STATE OF VERMONT
AGENCY OF TRANSPORTATION

PROPOSED IMPROVEMENT
BRIDGE PROJECT

MARLBORO
BRF 010-1 (43)

RECORD PLANS	
CONTRACTOR:	RENAUD BROTHERS, INC. - VERNON, VT
RESIDENT ENGINEER:	RON LEMAIRE
CONSTRUCTION BEGAN:	APRIL 8, 2014
CONSTRUCTION COMPLETE:	NOVEMBER 6, 2014
RECORD PLANS BY:	RON LEMAIRE & JENNA HYDE
I HEREBY CERTIFY THAT ALL THE CONSTRUCTION REQUIRED BY THIS SET OF DRAWINGS HAS BEEN ACCOMPLISHED AS INDICATED HEREIN.	
BY	RESIDENT ENGINEER
DATE 02/11/2016	
NOTE: Any further information concerning final quantities, amounts or other details relative to this project may be found at Central Files in the electronic archives.

393+50 • REVISED BRIDGE HAS 6 GIRDERS

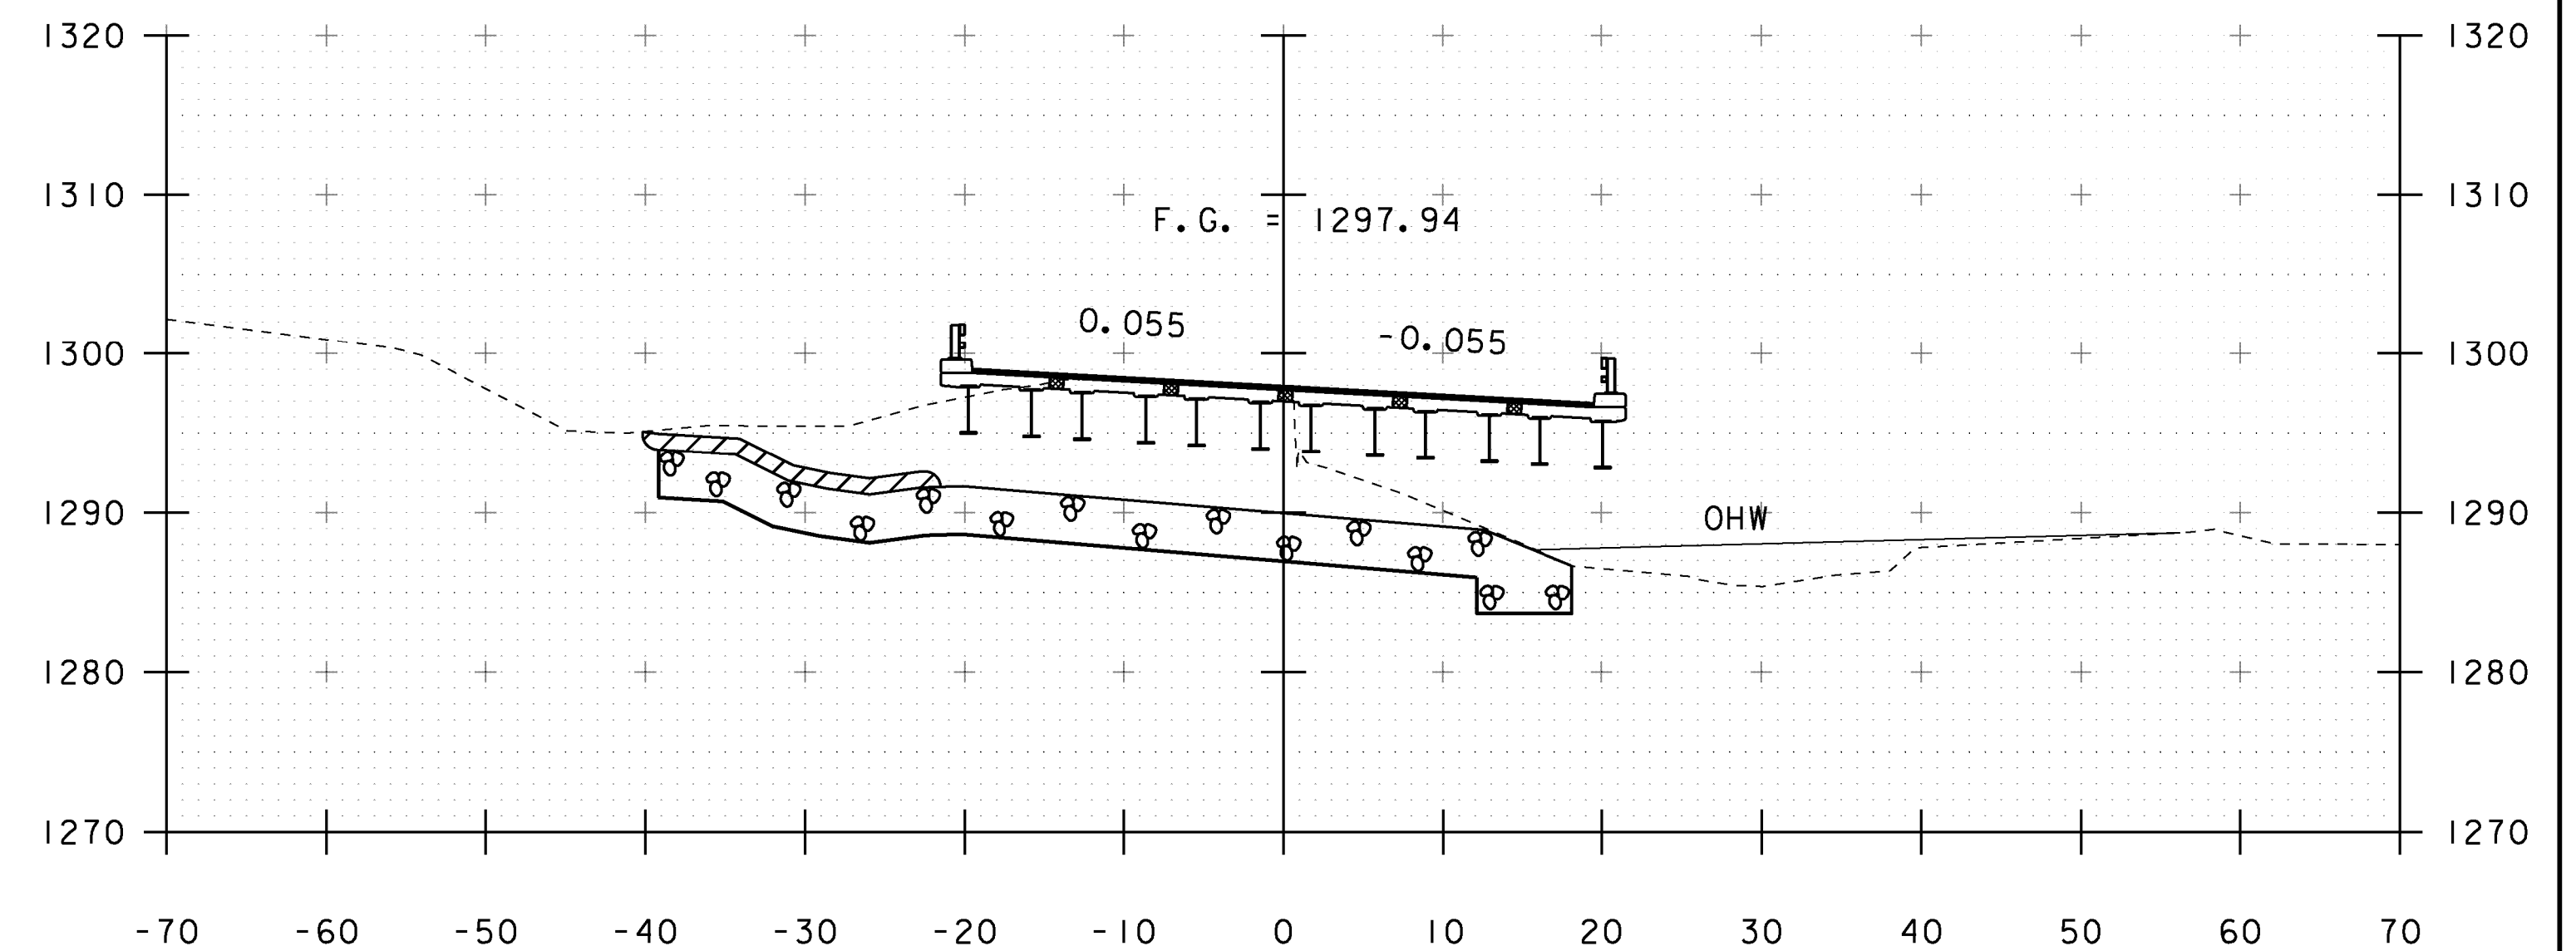
394+00
END BRIDGE STA ~~393+93.78~~
393+93.87

393+25
BEGIN BRIDGE STA ~~393+12.23~~
393+12.14
